**UN Regulation No. 149 (Road illumination devices)**

## **Revised proposal to correct and improve the text of UN Regulation No. 149**

### **Submitted by the Informal Working Group on Simplification of Lighting and Light-Signalling Regulations\***

Annex 7, paragraph 2.1.2.2.1. (a) and (b), amend to read:

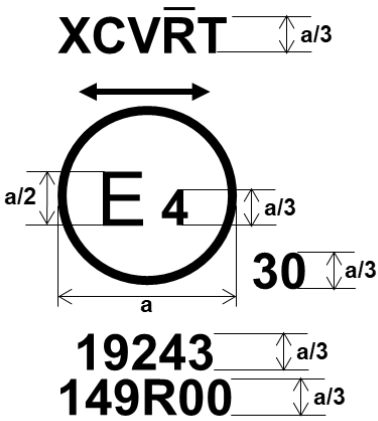
- “(a) Passing-beam, except for AFS system:  
- 50 R - B 50 L – 25L2 for headlamps designed for right-hand traffic;  
- 50 L - B 50 R – 25R2 for headlamps designed for left-hand traffic.
- (b) Passing-beam, for AFS system:  
Class C passing beam and each specified other passing beam class:  
50V, B50L<sub>r</sub> and 25RLL, if applicable”

1. The proposals to rename the element “Segment I C to D” in Table 8, to amend the luminous intensity requirements in Table 9, Part B and to correct Annex 7, paragraph 2.1.2.2.1. (a), are alignments with UN Regulations Nos. 98, 112 and 123.

Figure A13-III  
Marking example 3

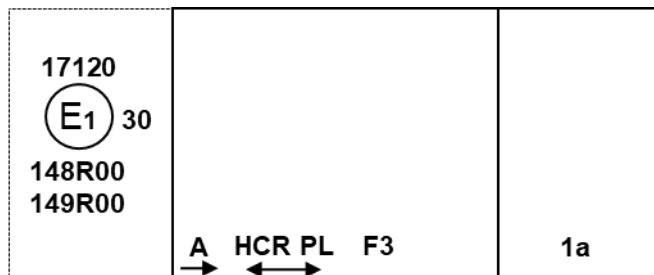
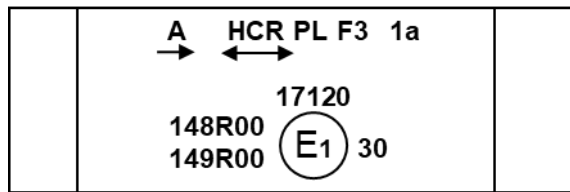
*Note:* The examples in Figures A13-III and A13-IV correspond to a lighting device bearing an approval mark comprising:

- (a) A front position lamp approved in accordance with the 00 series of amendments to UN Regulation No. 148. The horizontal arrow indicates the side on which the required photometric specifications are met up to an angle of 80° H;
- (b) A headlamp, Class B, with a passing-beam designed for right-hand traffic only and a driving-beam with a maximum intensity comprised between 123,625 and 145,125 candelas (as indicated by the number 30), approved in accordance with the requirements of this Regulation, as amended by the 00 series of amendments and incorporating a lens of plastic material;
- (c) A front fog lamp approved in accordance with the 00 series of amendments of this Regulation and incorporating a lens of plastic material;
- (d) A front direction indicator lamp of category 1a approved in accordance with the 00 series of amendments to UN Regulation No. 148.

3. Annex 13 has been editorially improved without changing its contents. An additional marking example 4-b (Figure A13-V) has been inserted to clarify the required markings for an additional lighting unit of an adaptive front-lighting system. This additional example was copied from example 8 (Figure 13) of UN Regulation No. 123.
